KENDALL COUNTY STORMWATER OVERSIGHT COMMITTEE PUBLIC HEARING

Petition 24-15 Kendall County Forest Preserve District

SUBJECT: Subat Nature Center

Comments Received June 4, 2024

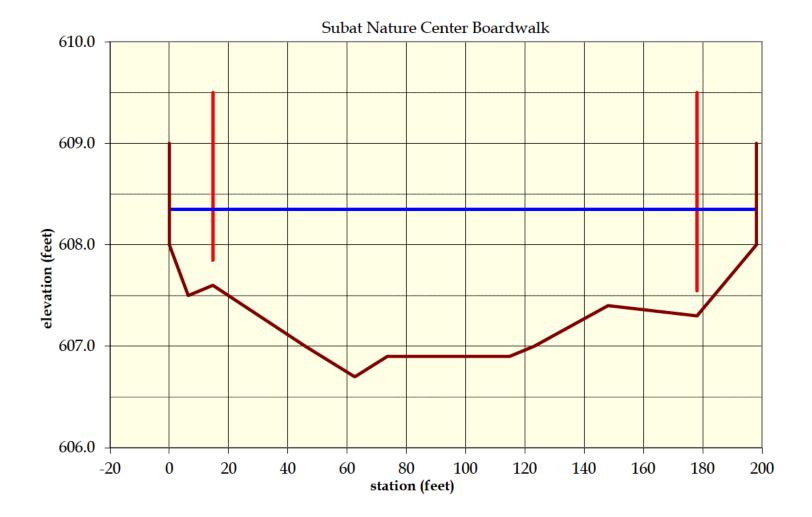
Comment: Stormwater report - The boardwalk spans a significant drainageway with an upstream area that appears to exceed one square mile. While this is not floodplain please verify the boardwalk will not have an adverse impact on Eldamain Road. (See attached Streamstats Report)

Response: The roadbed / berm grade and elevation of Eldamain Road north of River Road at the drainage culvert is raised several feet higher than the maximum grade of the delineated wetland at Subat. The proposed boardwalk will not have an adverse impact on Eldamain Road. The 100-year Water Surface Elevation (WSE) was calculated to be 608.35' and the low chord of the board walk will be elevated above WSE. Please see the attached calculations.

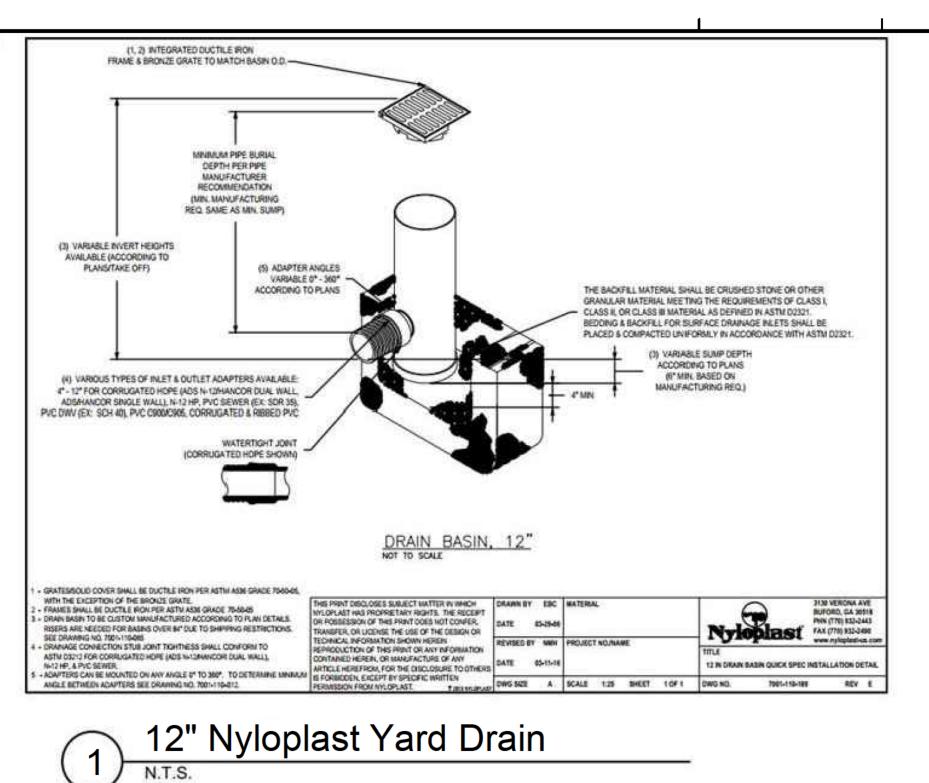
4. <u>Comment</u>: L501 – The Boardwalk detail depicts the 100-year flood elevation. We concur with the concept presented in the detail. Provide the 100-year flow elevation as well as the basis for determining that elevation at the boardwalk.

<u>Response</u>: The 100-year Water Surface Elevation (WSE) was calculated to be 608.35' and the low chord of the board walk will be elevated above WSE. The low point of the ground surface beneath the boardwalk is 606.9'. The boardwalk cannot exceed 30" from the surface without providing a handrail, therefore the top of the boardwalk shall be at elevation 609.4'. The low chord cannot be elevated any higher than the WSE as the depth of the structure is 12.5".
